## PROPOSAL FOR DRAFT AMENDMENTS TO DRAFT REGULATION No. [113]

This is a draft proposal for revisions to ECE draft regulation MH because of the new worldwide harmonized dipped beam pattern.

All of the following is based on the Proposal for a Draft Regulation MH: dated 12 August 1998; TRANS/WP.29/1998/42 and Addendum 1; dated 16 October 1998; TRAN/WP.29/1998/42/Add.1.

Figure C

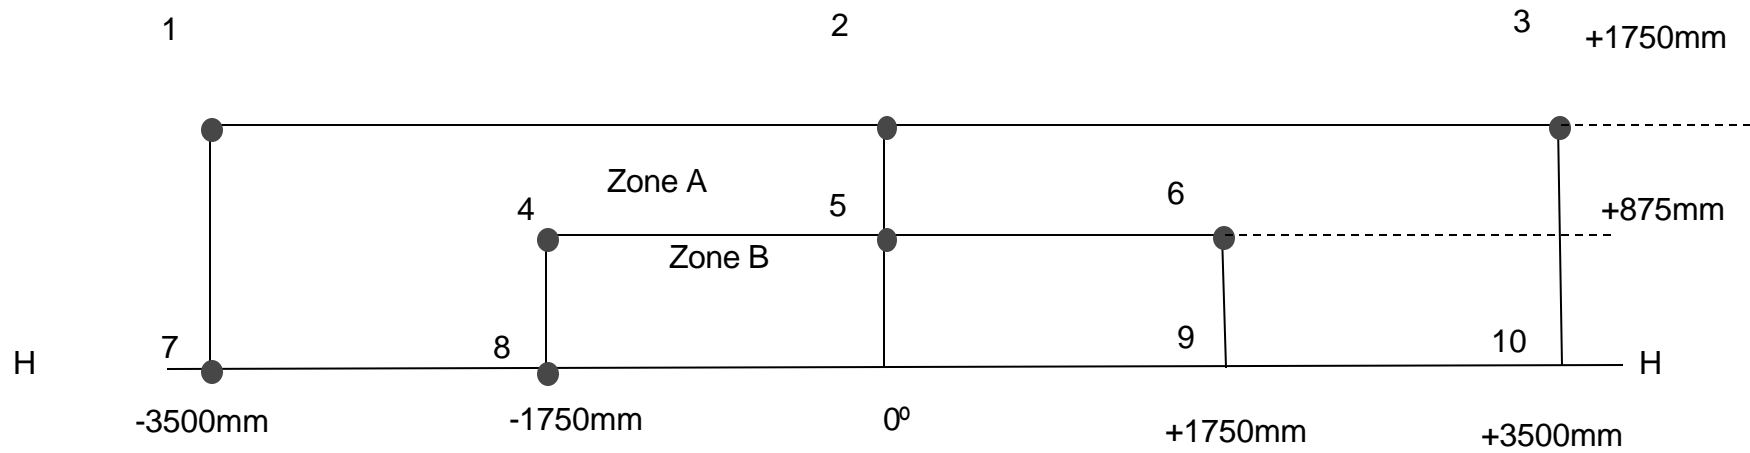
**6.2.7.** *For Class B or C or D headlamp, the illumination values in zones "A" and "B" as shown in Figure C in annex 3 shall be checked by the measurement of the photometric values of points 1 to 10 on this figure; these values shall lie within the following limits: \*/*

$$1 + 2 + 3 \geq 0.3 \text{ lux, and}$$

$$4 + 5 + 6 \geq 0.6 \text{ lux, and}$$

$$0.7 \text{ lux} \geq 7, 10 \geq 0.1 \text{ lux and}$$

$$0.7 \text{ lux} \geq 8, 9 \geq 0.2 \text{ lux}$$

*\*/ Illumination values in any point of zones A and B, which also lies within zone III, shall not exceed 0.7 lux.*

Note: This Figure is applicable to headlamps of Class B or C or D.  
The above measuring points are exclusively specified for this Figure C, and not identical to the points of the same numbers specified in Figure D.
